ADDENDUM

Project: Meetinghouse and Parking Addition
Prairie Grove AR,
Springdale AR Stake

Addendum No.: 01

Date: August 12, 2025

E001

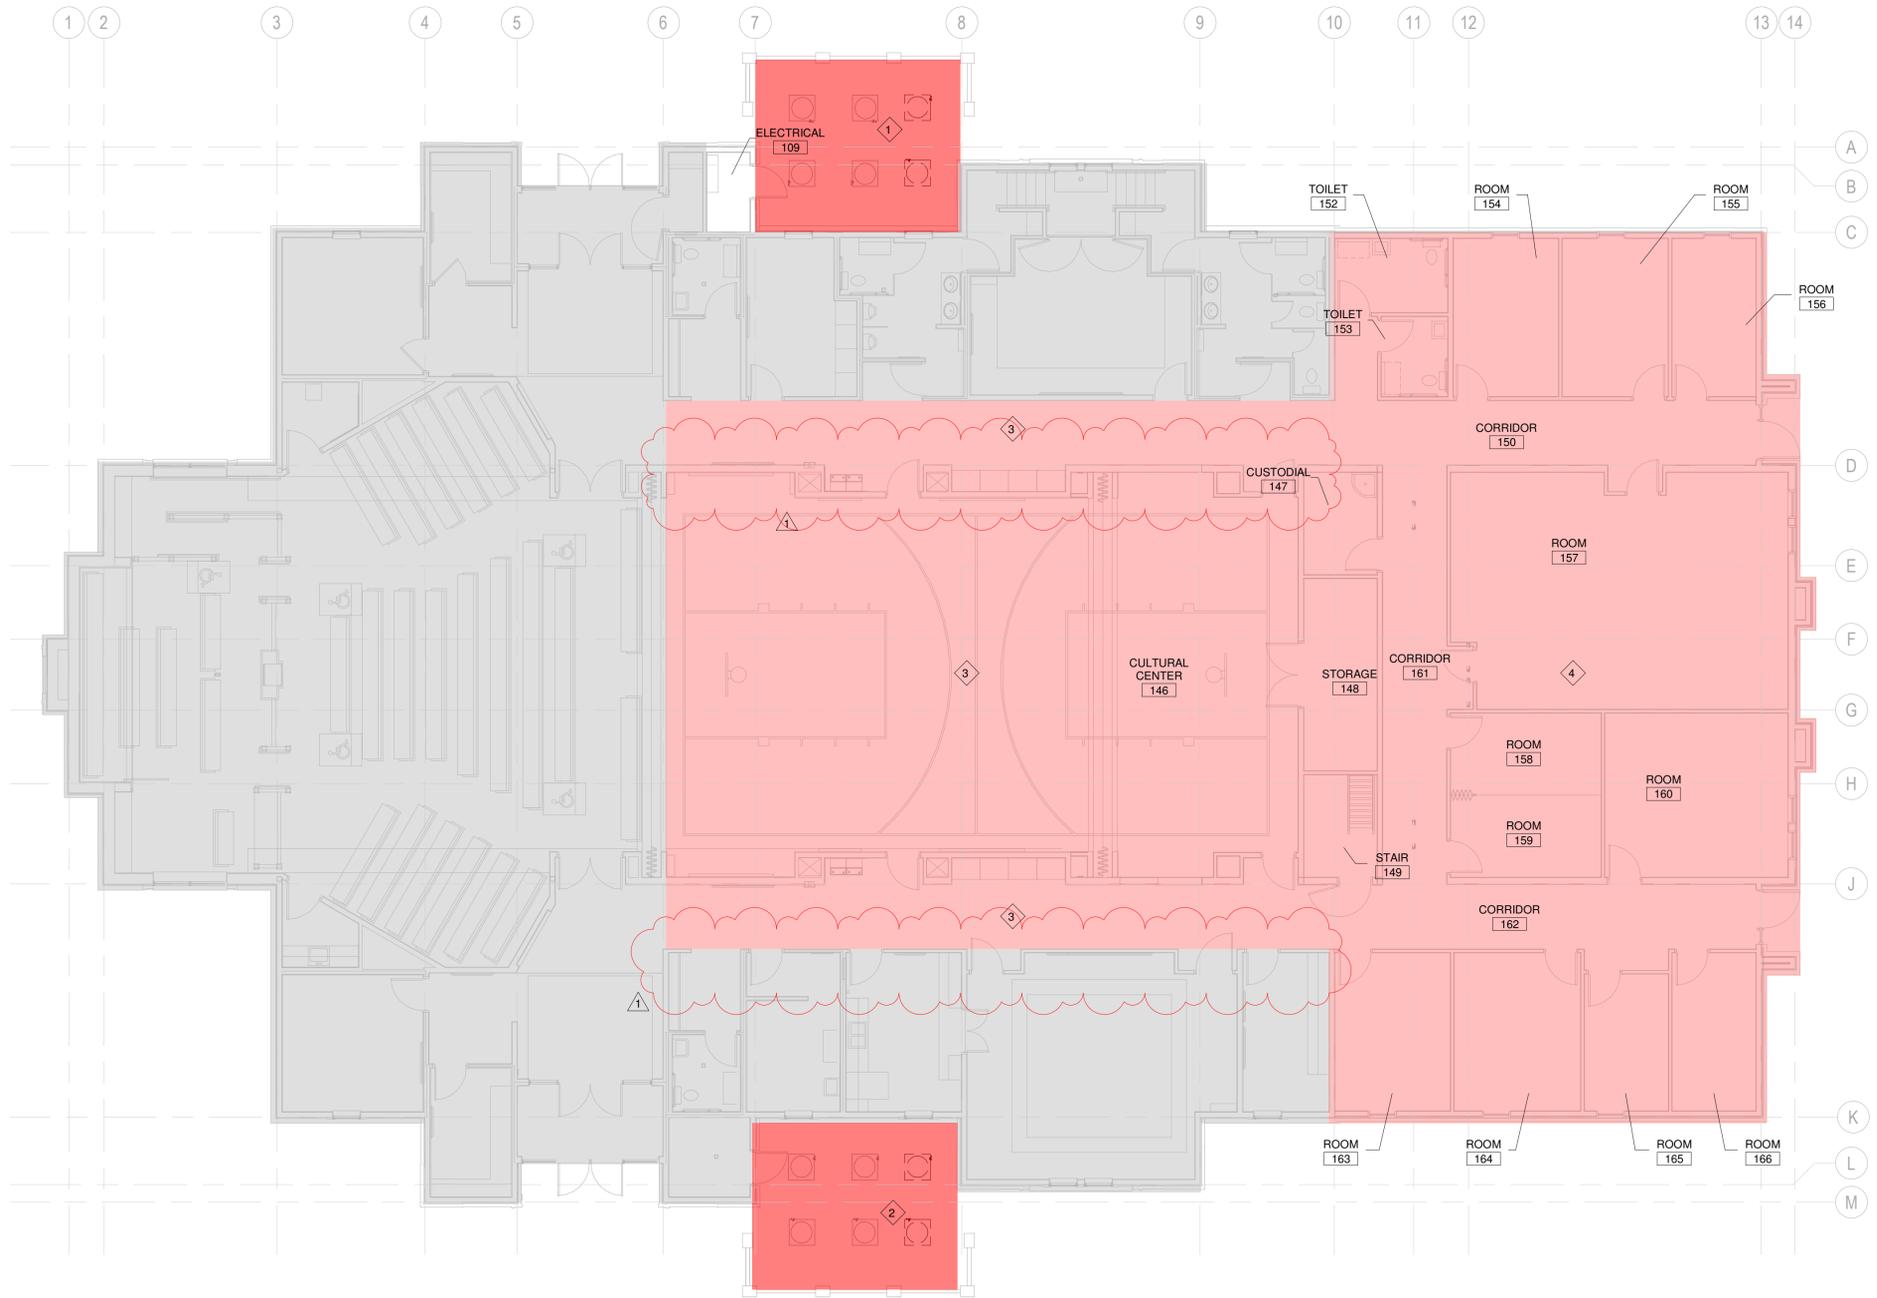
1. All electrical sheets show revised engineer of record.
2. E001
 - a. Revised direction to demolish existing lights in corridors to replace with new fixtures reusing existing circuitry and controls.
 - b. Edited Keynote 3 to specify demolition in corridors.
3. E101
 - a. Added new fixtures in corridors to replace existing fixtures reusing existing circuitry and controls.
 - b. Added Keynote 14 to replace existing fixtures and re-use circuitry and controls.
4. E111
 - a. Removed power for scoreboard and Skyfold door.
 - b. Removed keynotes 5-9 for scoreboard and Skyfold door.
5. E601
 - a. Removed circuits for Skyfold door and scoreboard and revised E-12, E-19, E-21, and E-21 to spares.
6. E608
 - a. Revised EOR Information and site details.
